Docket No. 50-334
and 50-412
Serial No. BV-92-001

SUBJECT: CHANGE TO TECHNICAL SPECIFICATION BASES SECTION 3/4 4.9
PRESSURE/TEMPERATURE LIMITS (TAC NOS. M81395 AND M81396)

Beaver Valley Power Station
Units 1 & 2

FIGURE B 3/4 4-3

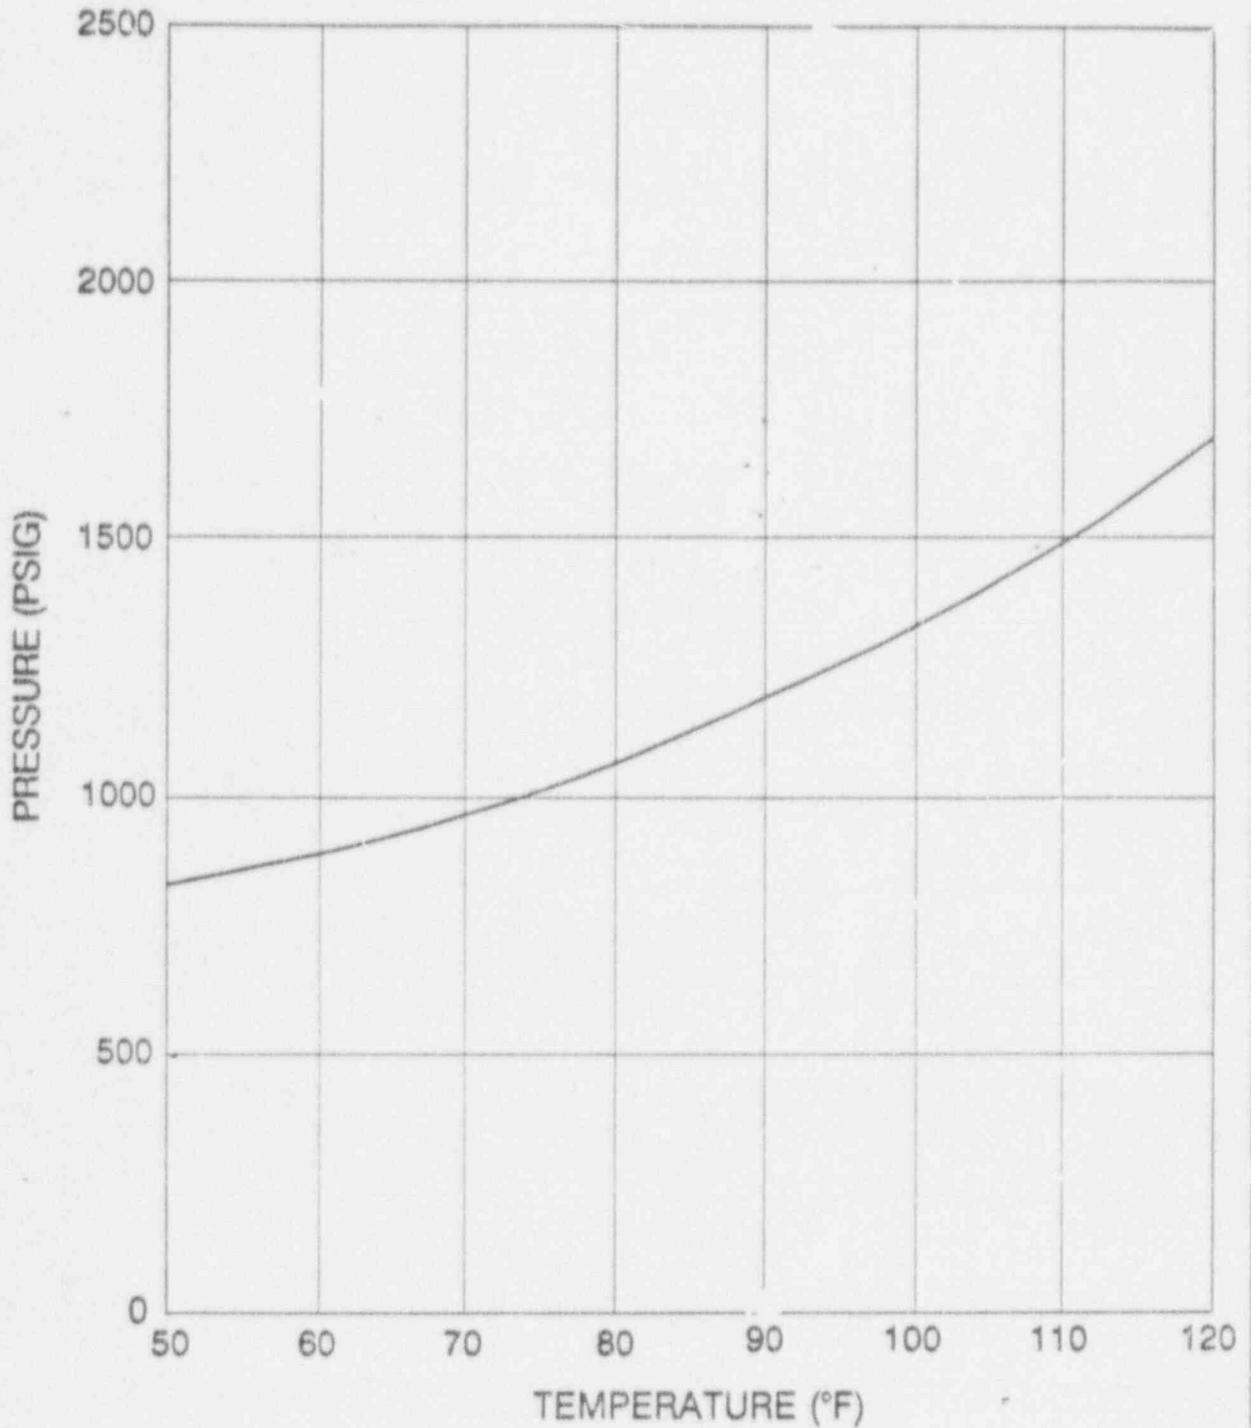
The staff has reviewed the proposed pressure-temperature limits for the isolated loop as shown in proposed Figure B 3/4 4-3. The staff finds that the pressure-temperature limits are conservative and satisfy SRP 5.3.2 and RG 1.99, Rev. 2. Therefore, the staff has no objection to your proposed

pressure-temperature limits in Bases Section 3/4/ 4.9 and the addition of Figure 3/4 4-3. This resolves Unresolved Issue 50-412/90-01.

Pressure-temperature limit curves shown in Figure B 3/4 4-3 were developed for the limiting ferritic steel component within an isolated reactor coolant loop. The limiting component is the steam generator channel head to tubesheet region. This figure provides the ASME III, Appendix G limiting curve which is used to define operational bounds, such that when operating with an isolated loop the analyzed pressure-temperature limits are known. The temperature range provided bounds the expected operating range for an isolated loop.
